ADDENDUM 1 – JOB 22616

TO: All prospective bidders on Project NH-3-001(031)201 and NH-3-001(033)200, Job No. 22616 scheduled for the November 14, 2025 bid opening.

PLAN ADDENDUM SUMMARY AND APPROVAL

PROJECT INFORMATION		
Date: 11/10/2025	Project: NH-3-001(031)201 & NH-3-001(033)200	PCN: 22616
Lead Designer: SRF Consulting	Technical Support: Jesse Carlsen	
Bid Opening Date: 11/14/2025	Job Number: 22616	Addendum Number: 1

Revised 11/10/2025	STATE	PROJECT NO.	SECTION NO.	SHEET NO.
	ND	NH-3-001(031)201	20	4

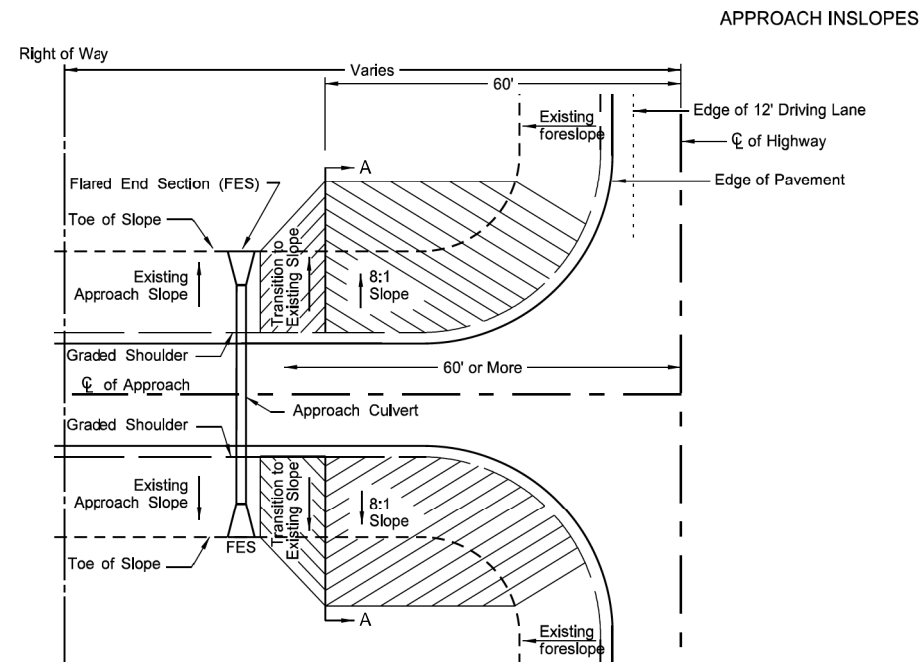
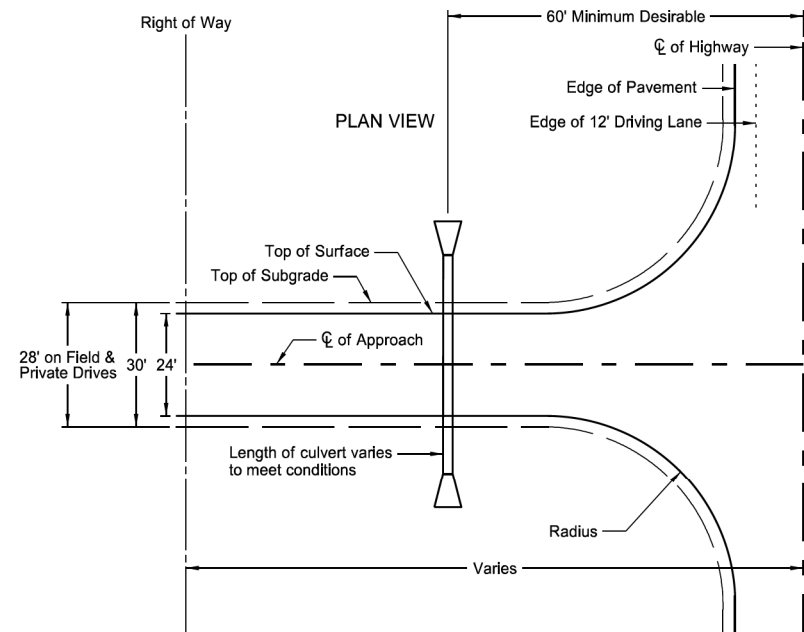
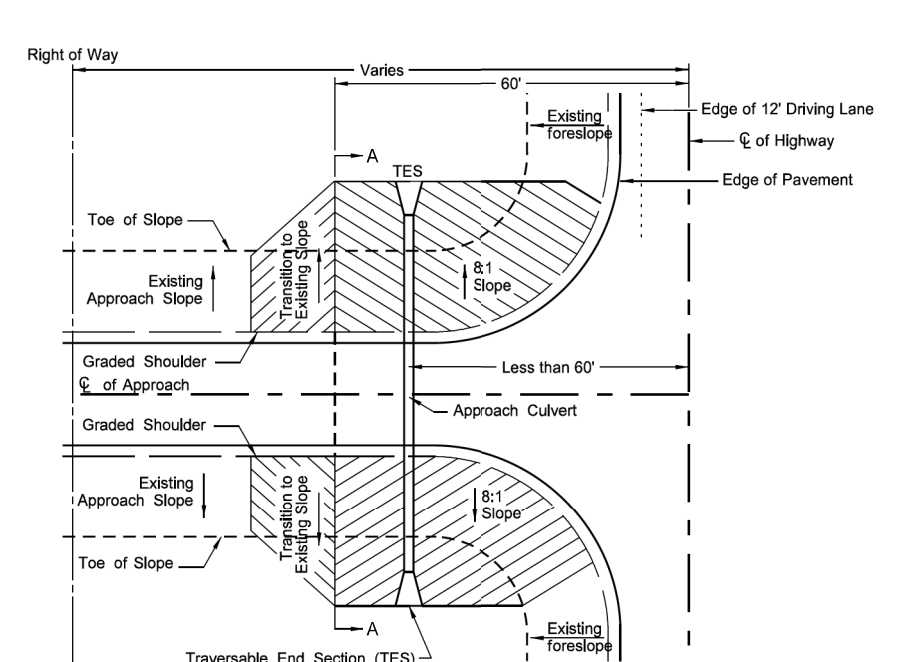
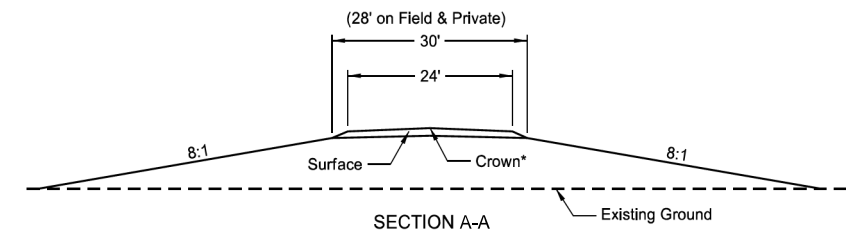
PLAN SHEET CHANGES		
Section	Sheet(s)	Description
8	1	Updated Railroad Flagging Quantity to match Special Provision Bidding Directions. Updated Approach Foreslope quantity to match sheet 20-4 Added Bid item for blinker sign
8	2	Addition of items on sheet 8-1 shifted items to sheet 8-2
6	3	Revised note 754-P02 to include blinker sign for price bid inclusion
20	4	Updated table to include an "Estimated Embankment CY" per approach flattening

Station	Quantity		Existing Slope (A)		Estimated Embankment (A)		Extend Culvert (B)	
	BK (EA)	AHD (EA)	BK (X:1)	AHD (X:1)	BK (CY)	AHD (CY)	BK (LF)	AHD (LF)
20678+97 LT	1	0	5.3	7.0	40.0	-		
20679+02 RT	0	1	7.9	5.8	-	30.0		
20703+23 LT	1	0	4.9	6.1	100.0	-	9	
20711+67 LT	1	0	5.4	6.9	30.0	-		
20759+16 RT	0	1	8.3	5.4	-	130.0		6
20795+61 RT	0	1	7.4	5.3	-	50.0		7
20857+72 LT	0	1	6.3	5.6	-	30.0		5
20871+28 LT	1	1	4.2	4.1	60.0	50.0	11	14
20898+08 LT	0	1	6.3	4.6	-	80.0		6
20982+01 LT	1	0	5.1	6.6	50.0	-	5	
21005+52 RT	0	1	7.2	5.8	-	10.0		
21029+58 LT	0	1	6.3	5.8	-	70.0		6
21059+35 LT	0	1	6.6	5.4	-	70.0		3
21082+51 RT	0	1	6.5	5.2	-	40.0		10
21082+55 LT	0	1	12.1	5.7	-	20.0		6
21175+55 LT	1	1	4.7	5.7	70.0	40.0	12	12
21214+22 LT	1	0	5.2	6.1	50.0	-	4	
21242+93 RT	0	1	7.6	5.5	-	50.0		13
21245+80 RT	1	0	5.6	7.2	40.0	-		
21245+84 LT	1	0	5.6	7.2	40.0	-	3	
21252+21 RT	1	1	4.9	4.9	60.0	60.0	8	11
21257+43 LT	1	0	5.8	6.9	50.0	-	11	
Totals	11	14					63	99
